**LICENSE SUA-1341  
DOCKET NO. 40-8502**

**RE: Annual SERP Summary for 2000**

**COGEMA Mining, Inc.**  
**Performance-Based License Section 9.4 (D), SUA-1341**  
**2000 Annual SERP Summary Report**

GEOLOGY	STATE WYOMING	COUNTY JOHNSON
DIVISION 3. Vickers	DATED	REVISED DEC. 2000
SURVEY	SCALE none	
DATA PREP P. Hague	MAP ID	<b>FIGURE 3.9</b>

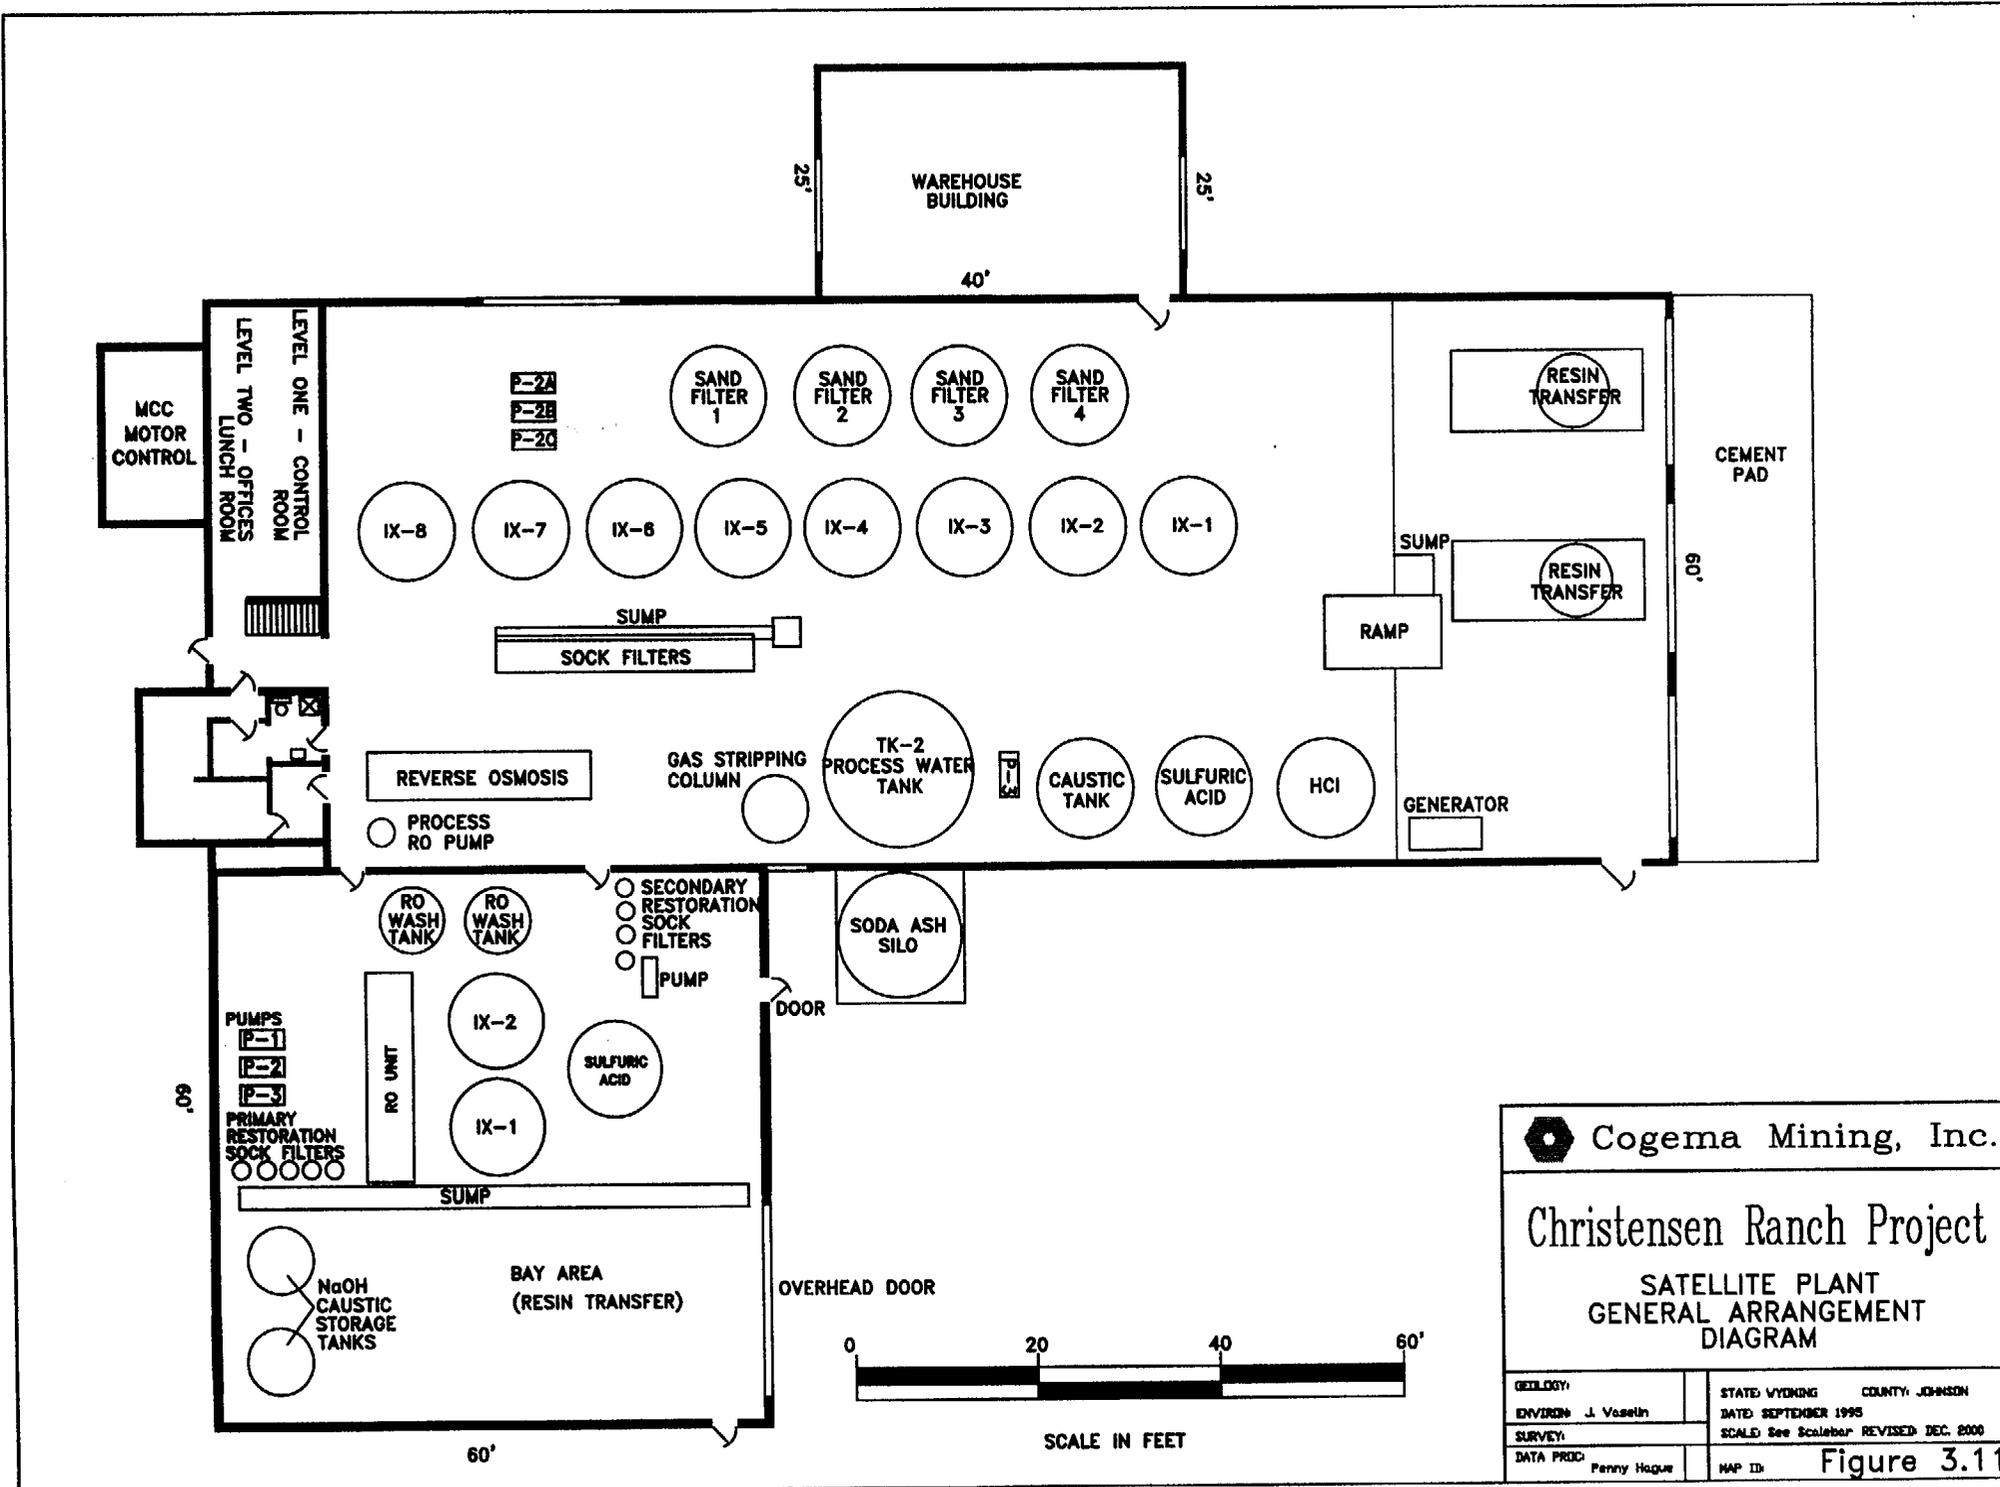
The SERP recommended that Figure 3.9 (Irigaray Recovery Facility - General Arrangement Diagram) of the approved application, be revised to show the main changes in the layout of the process facility at the Irigaray Plant. It was also recommended that a second page be added to Figure 6.1 (Typical Restoration Process) of the approved license, to better show the layout for the reverse osmosis/permeate injection phase of restoration.

The SERP recommended that Figures 3.9 and 3.11 of the License Renewal Application, be revised to show the updated layout of the restoration plants including the air strip columns. The SERP also recommended that the operation of the air strip columns be addressed in existing or new SOPs.

The SERP reviewed layout changes to the Irigaray process facility conducted for restoration purposes. The changes consisted of the following.

1. Moved the reverse osmosis (RO) unit (# 1&2) from the well field building to the plant annex.
2. Added a sulfuric acid tank in the plant annex. Note that the sulfuric acid tank at the well field building is no longer used.

3. Eliminated four of the Irigaray Elution tanks.
4. Converted two existing tanks into holding tanks for RO feed and permeate injection water.

FIGURE 5.1

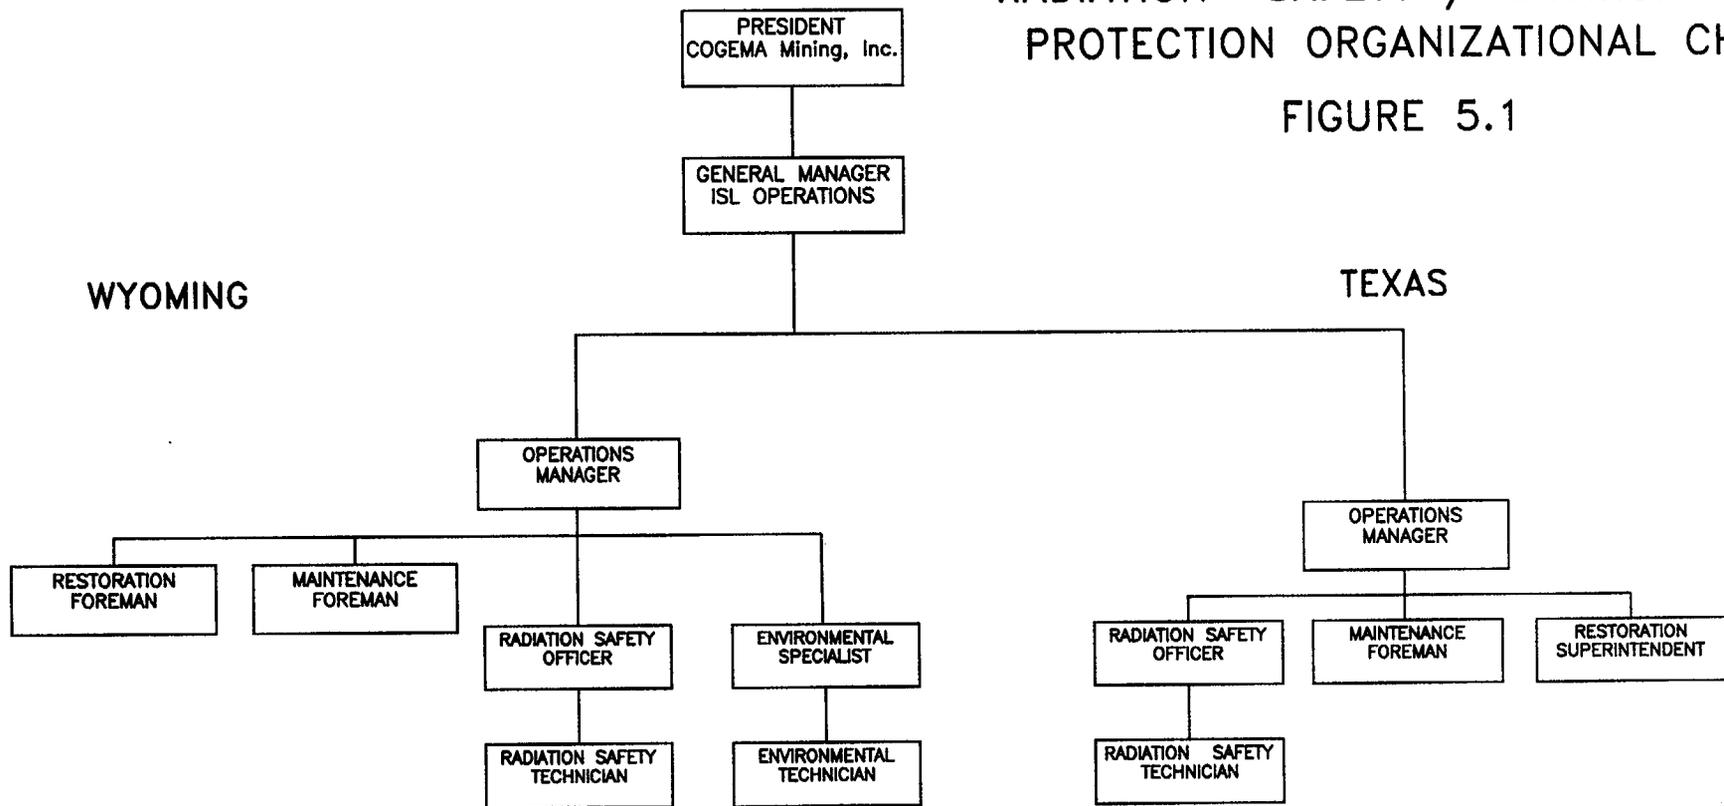
The SERP evaluated the elimination of the Manager, Environmental and Regulatory Services position (effective May 1, 2000), due to a continuous reduction in operations. COGEMA employees Donna Wichers (General Manager) and John Vaselin (Radiation Safety Officer) would assume the position responsibilities in addition to continuing their current functions. The SERP noted that each has over 20 years of experience in the safety and environmental fields of uranium mining. The SERP also noted that both employees have the authority to suspend activities which are unsafe or in violation of license or regulation requirements. The SERP determined that the position elimination would only require that Section 5.1 of the License Renewal Application be revised to update the changes.
